**TOWN OF NEWBURGH  
PLANNING BOARD  
TECHNICAL REVIEW COMMENTS**

**PROJECT: PEAK SUMMIT SUBDIVISION**  
**PROJECT NO.: 16-13**  
**PROJECT LOCATION: SECTION 17, BLOCK 1, LOT 40.2**  
**REVIEW DATE: 3 OCTOBER 2016**  
**MEETING DATE: 6 OCTOBER 2016**  
**PROJECT REPRESENTATIVE: ZEN DESIGN**

Re: Peak Summit Subdivision  
Fostertown Road  
Section 17 Block 1 Lot 40.2  
Town Project : 16-13

## Comments received from McGoey, Hauser & Edsall, dated 08/23/2016:

|            | <b>ENGINEER</b><br>WILLIAM MOREAU, P.E. |            | <b>PEAK SUMMIT ENTERPRISES, INC.</b><br>3 LOT SUBDIVISION<br>LOT LAYOUT<br>FOSTERTOWN ROAD, SBL: 17-1-40.2<br>TOWN OF NEWBURGH, ORANGE COUNTY, NY |              |

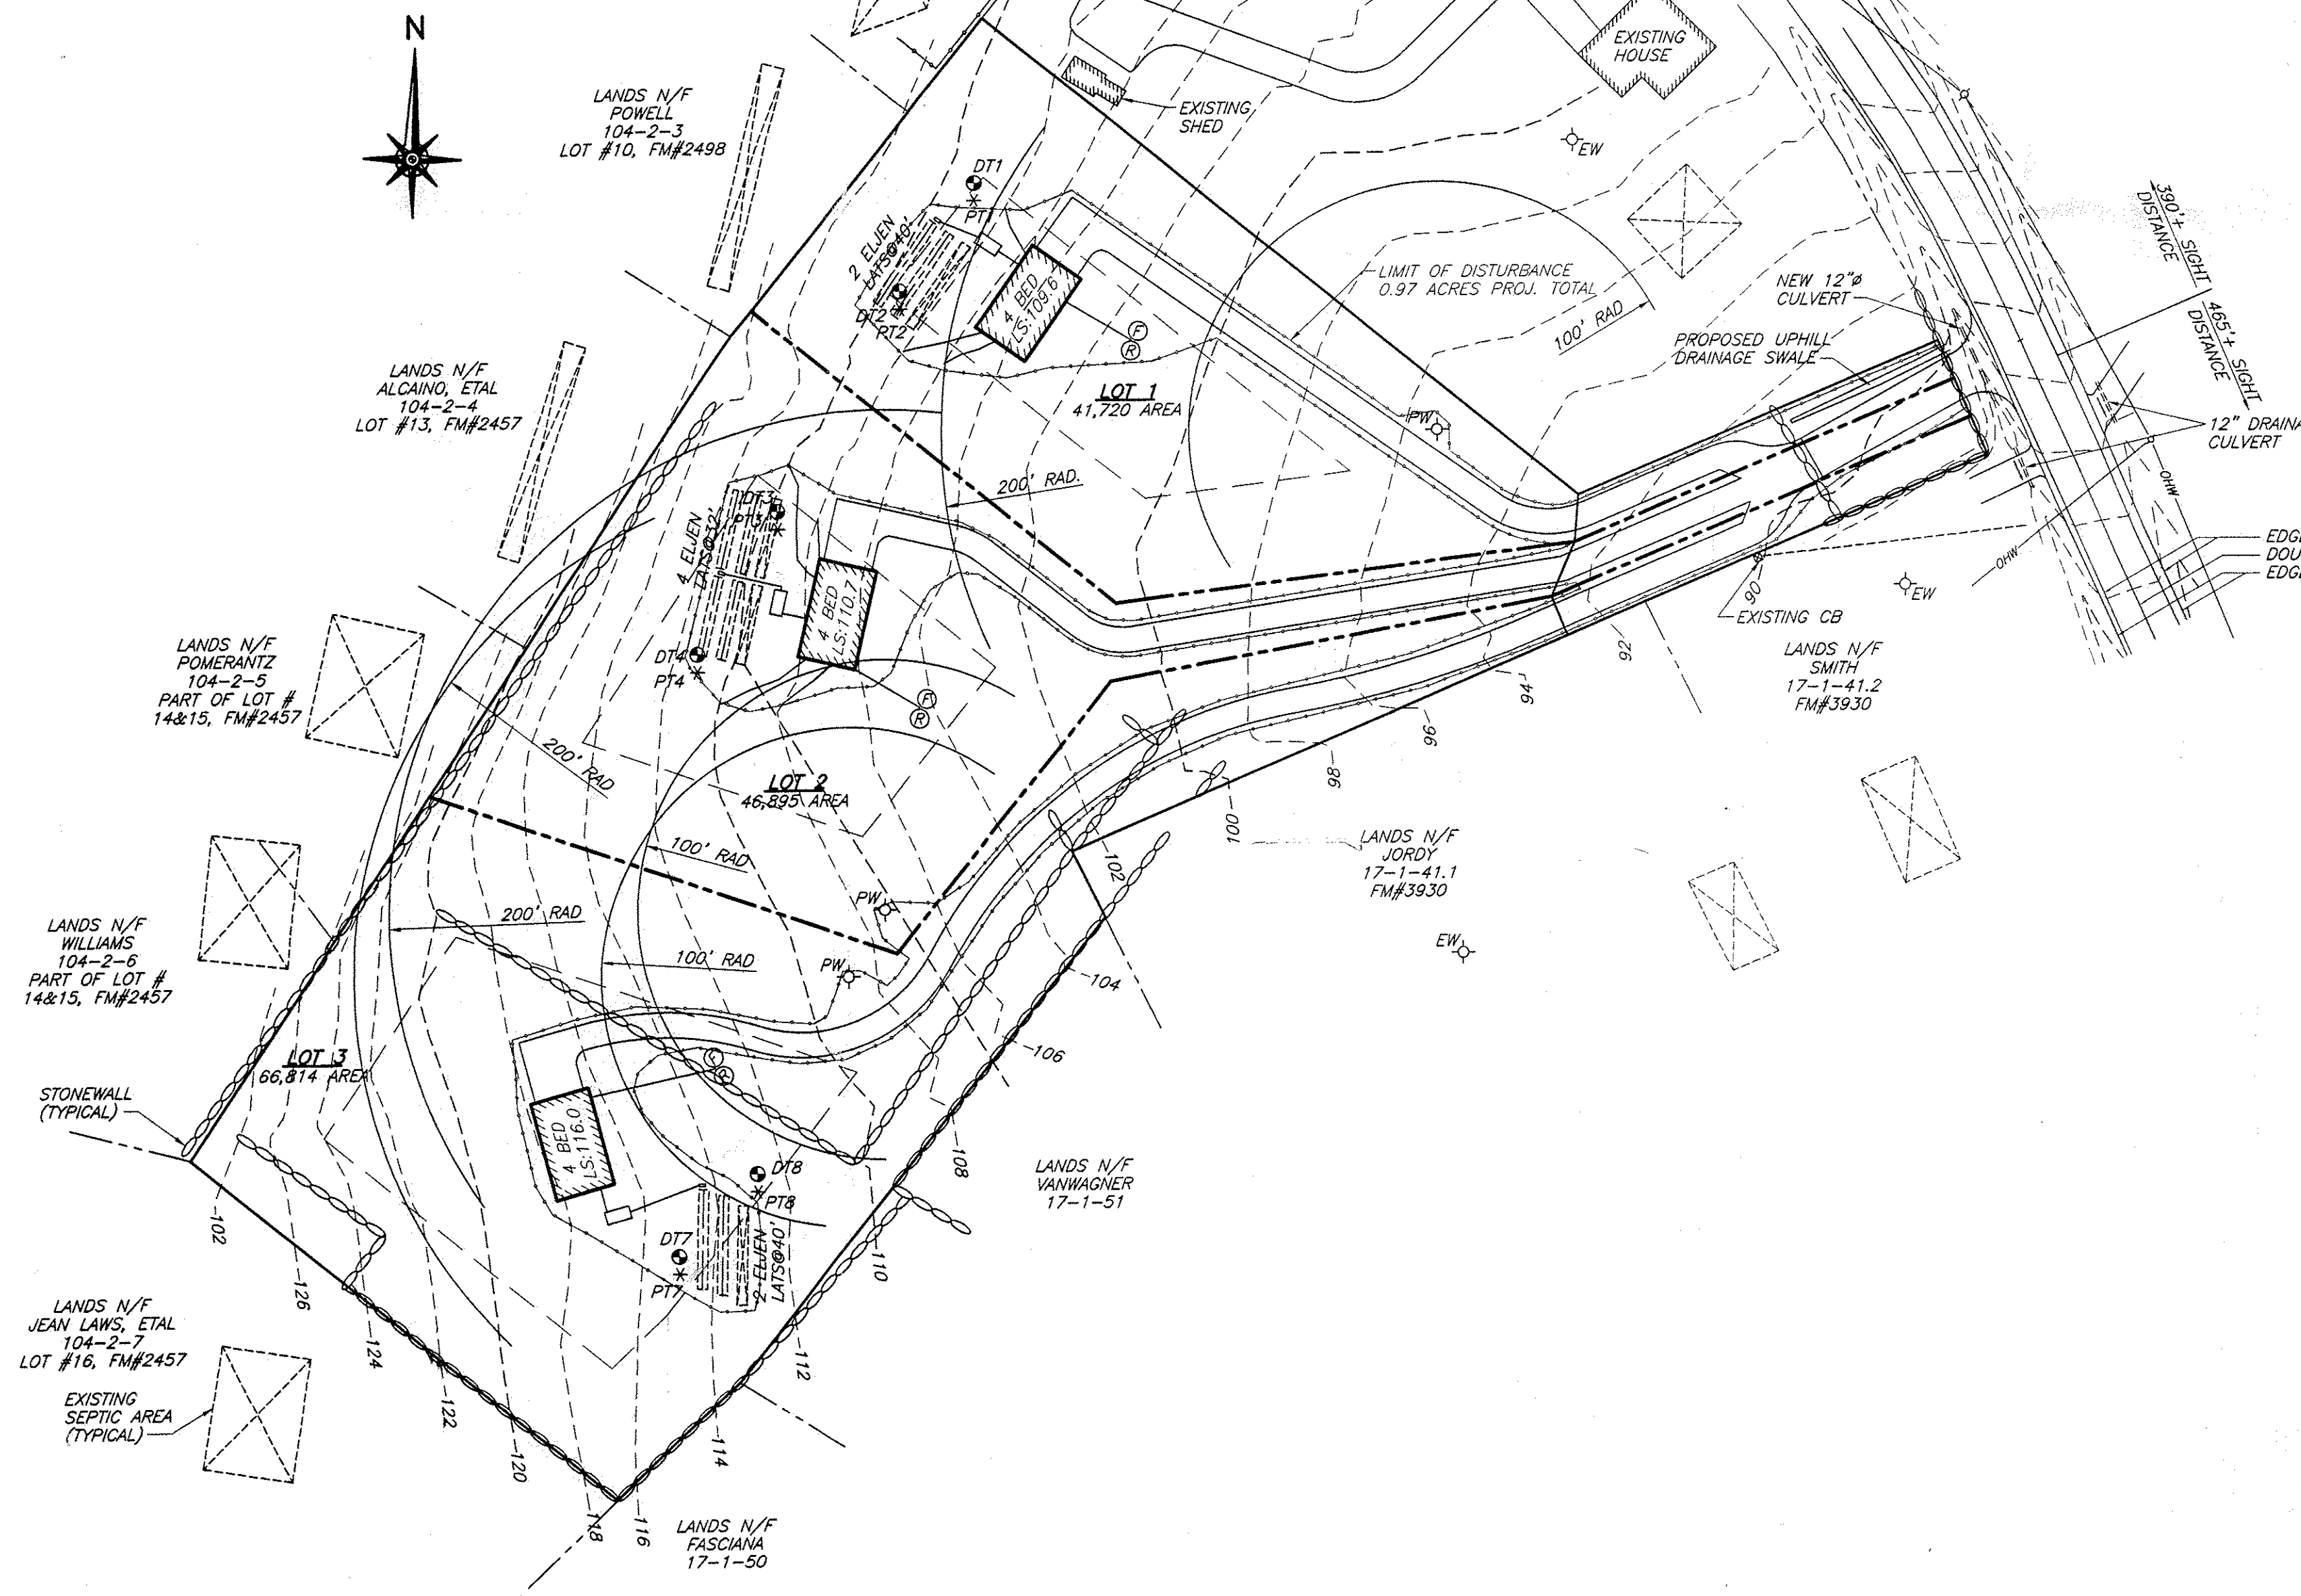
4. Lowest sewer elevations should be depicted on the plan sheets. Two of the lots have the sanitary sewer systems located behind and up gradient of the residential structures - **These elevations have been added to the plans**

10. Check the 120 contour across proposed lot #3, there appears to be an added line - **This extra line has been removed.**
11. Label separation distances between wells and septics, utilizing radius lines. - This has been added to the plans.

|  | <b>ENGINEER</b><br>WILLIAM MOREAU, P.E. | <b>PEAK SUMMIT ENTERPRISES, INC.</b><br>3 LOT SUBDIVISION<br><b>SEPTIC DETAILS</b><br>FOSTERTOWN ROAD, SBL: 17-1-40.2<br>TOWN OF NEWBURGH, ORANGE COUNTY, NY |

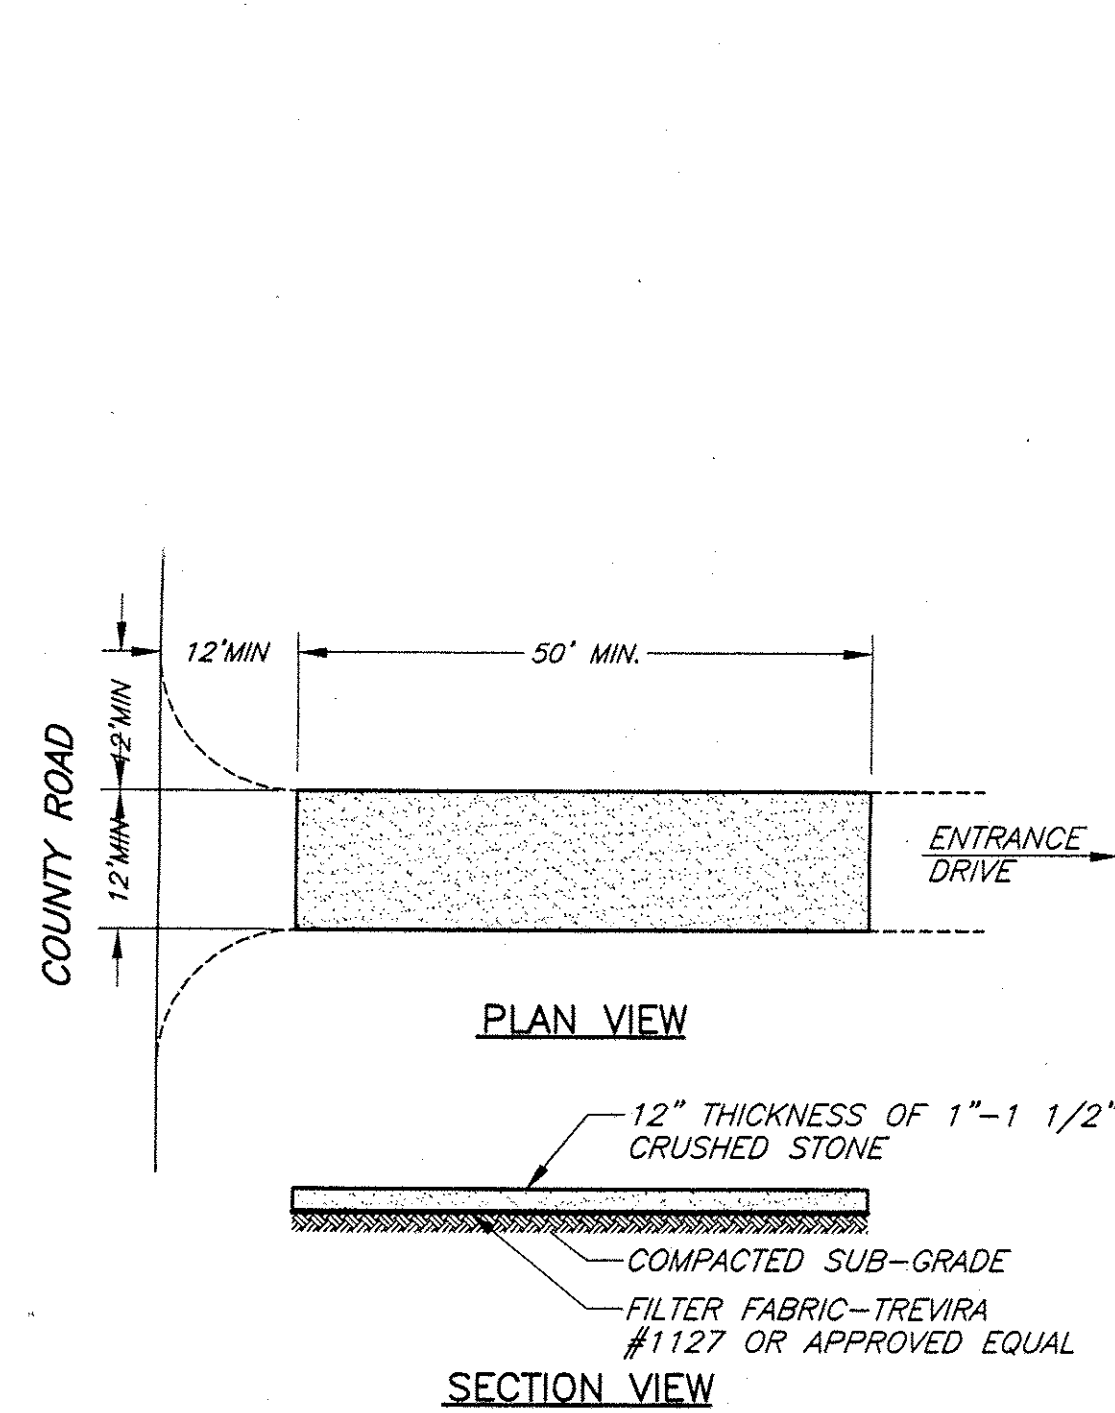
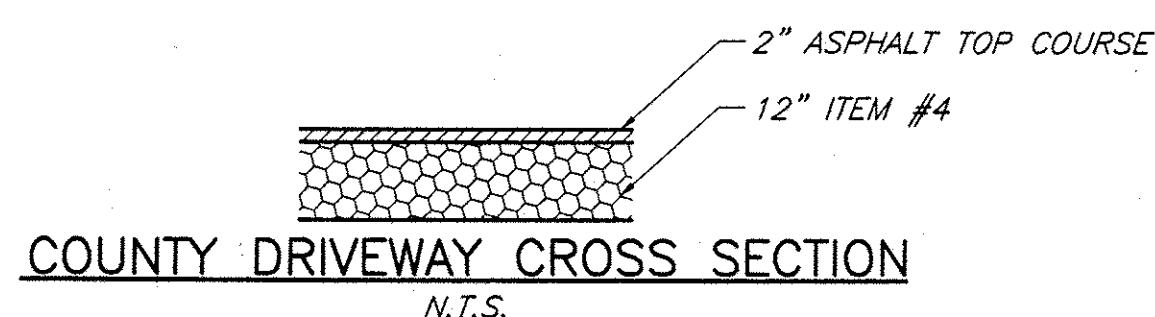
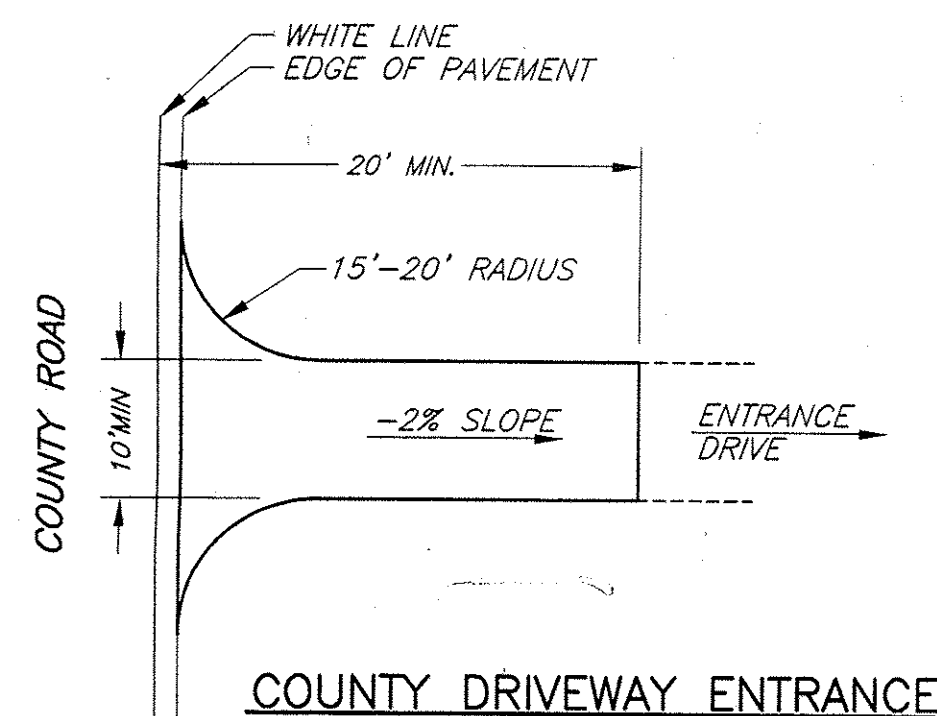
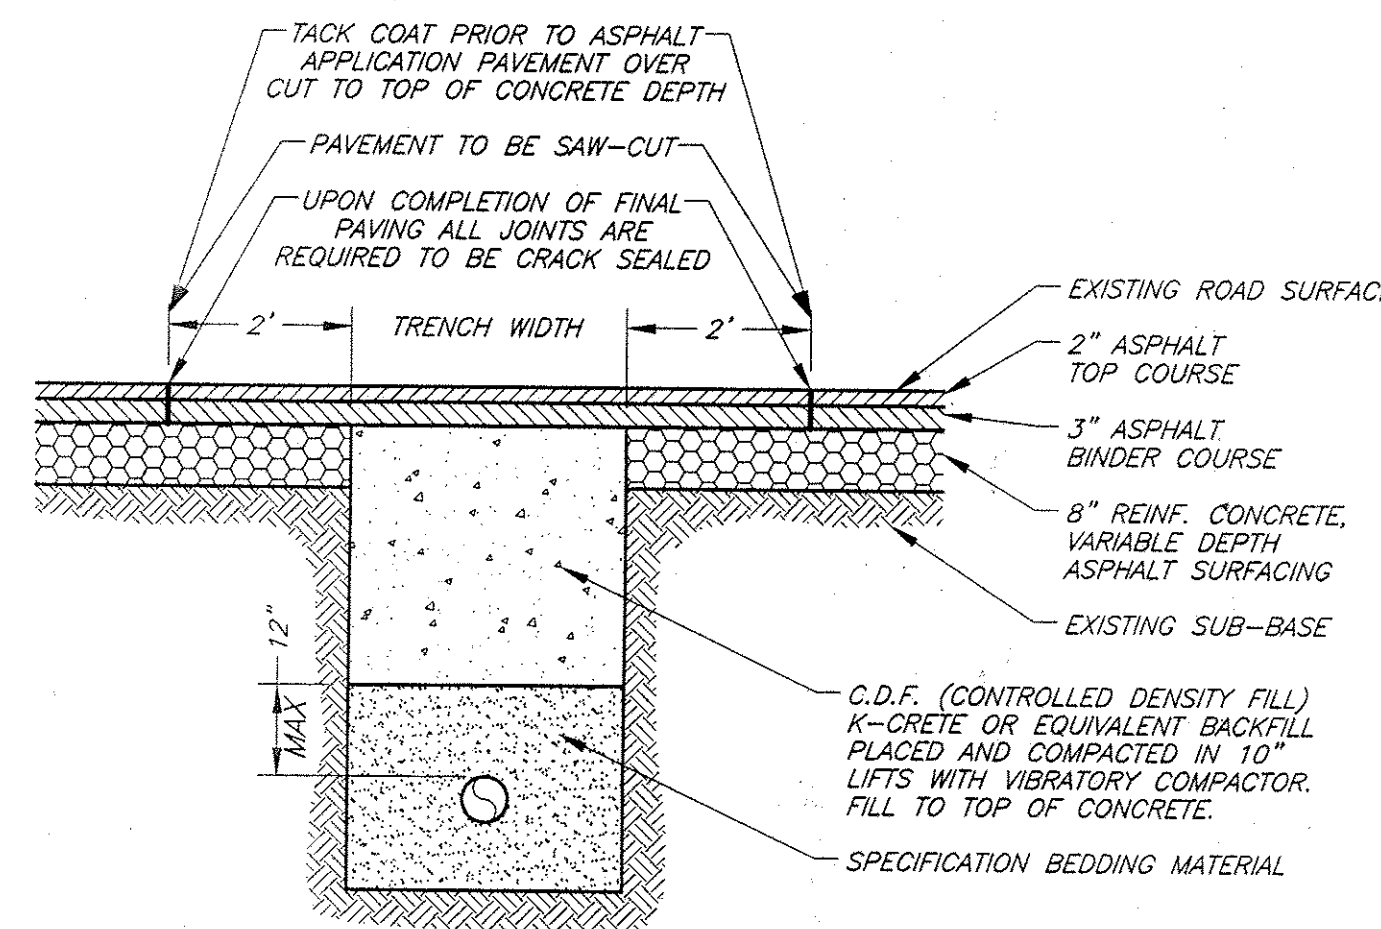
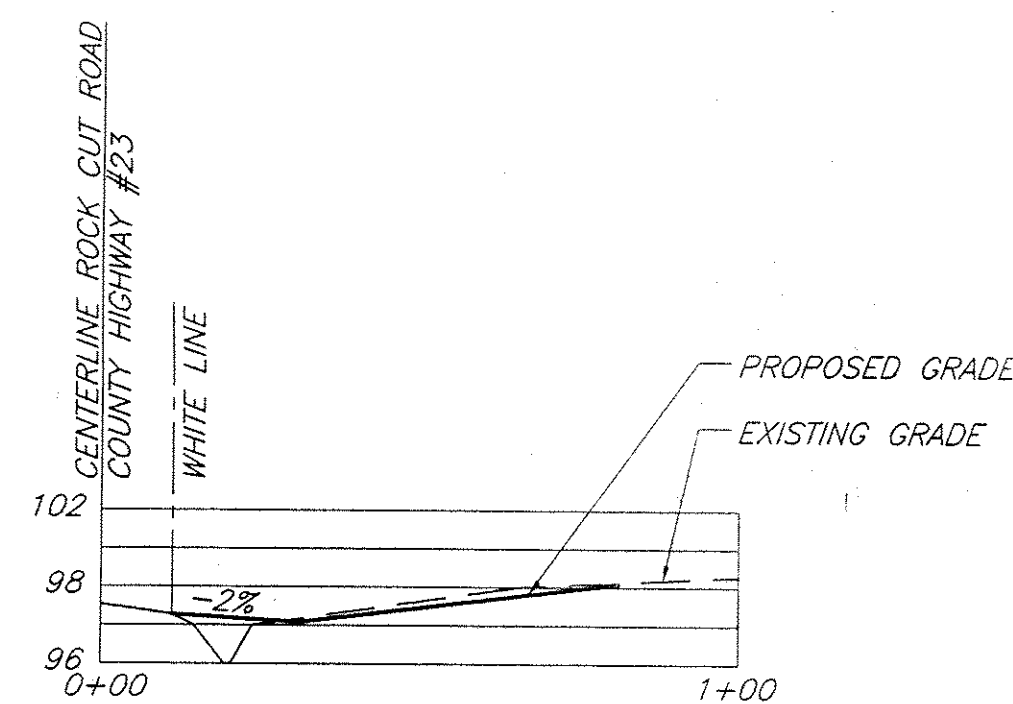
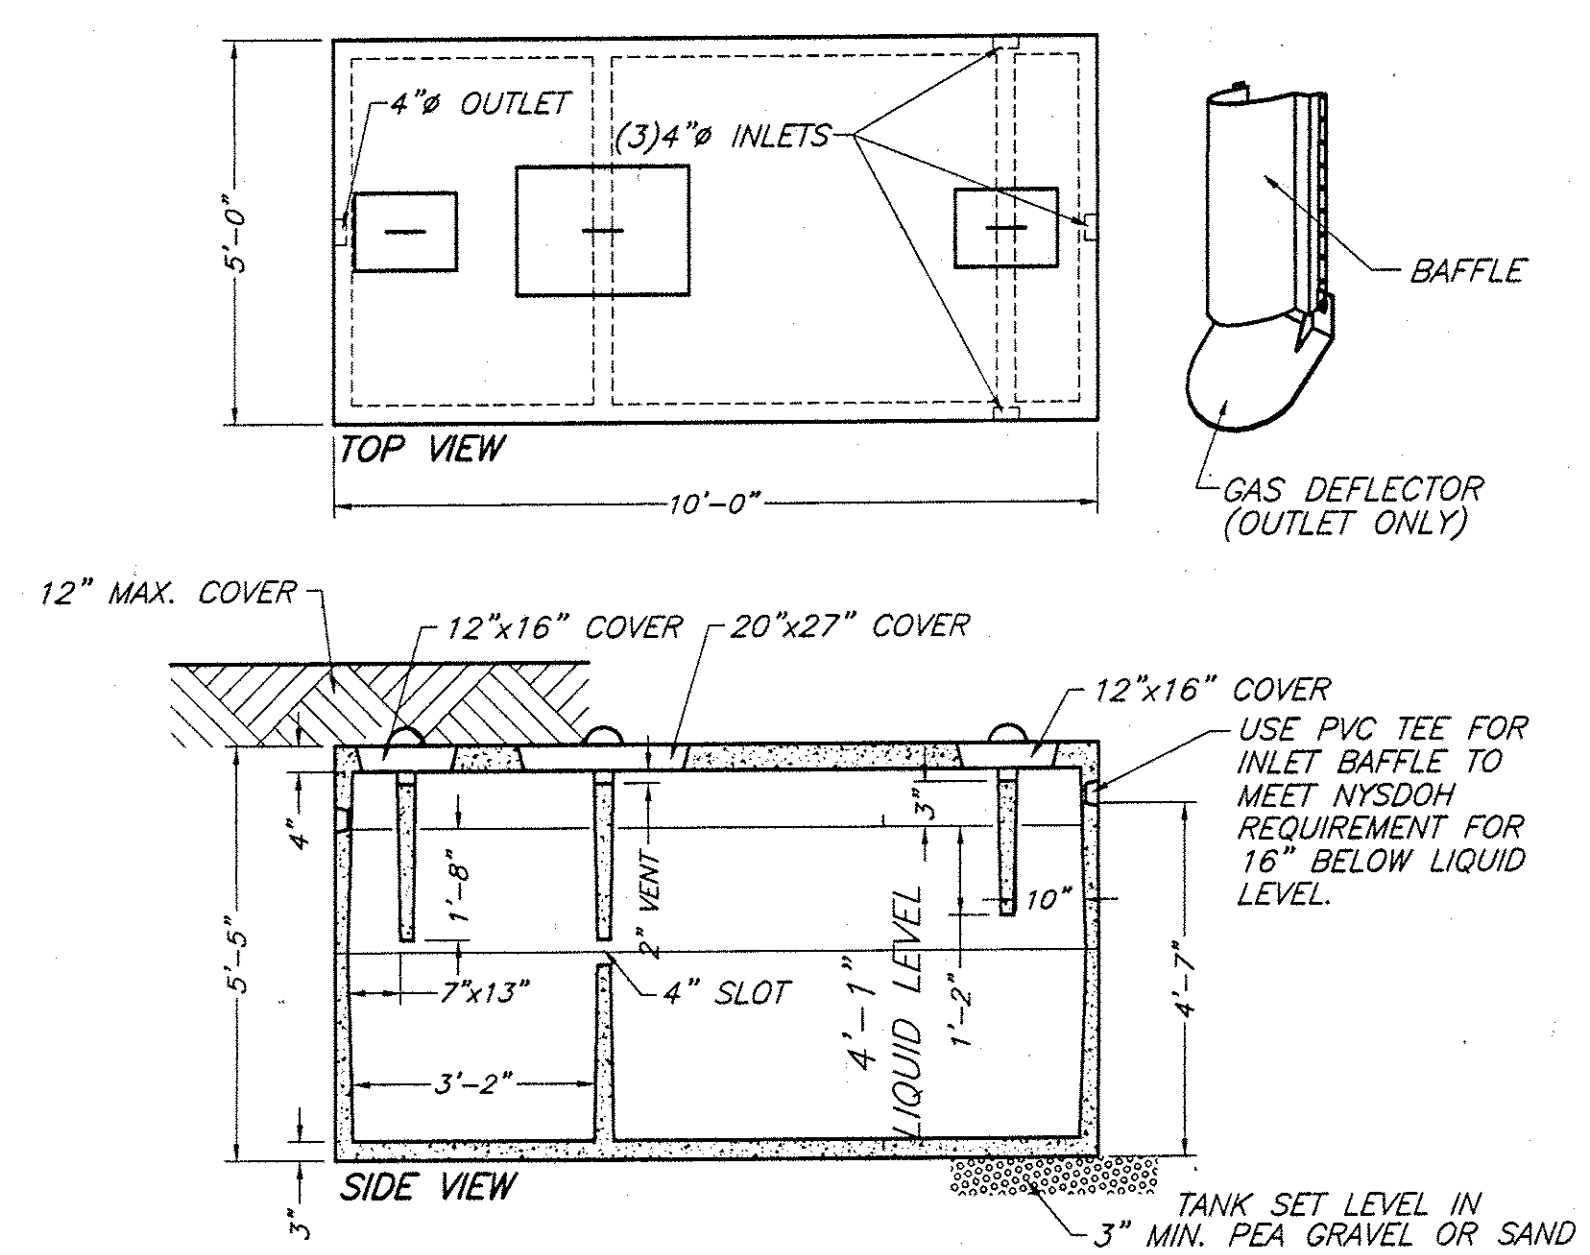
4. Sheet 3 of 4 is identified as septic details while the majority of the septic system details appear on sheet 4 of 4 labeled miscellaneous details.
5. Common driveway access and maintenance agreement approval from Mike Donnelly's office is required.
